Dixie-Narco

Service Bulletin

270

SUBJECT: Vend Rotor - with rear can retainer

Fig. 1

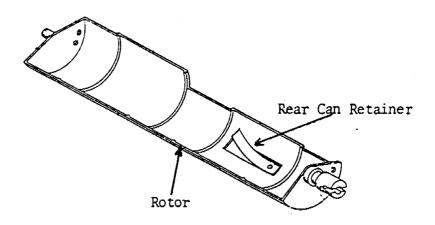
REASON: To provide a feature that will retain the rear can if the vender

is tilted.

ORDER AS: Part #D801,201,000.51 - Vend Rotor

When a vend rotor is ordered for a 1 1/4" deeper vender the rotor described hereon will be shipped as a replacement.
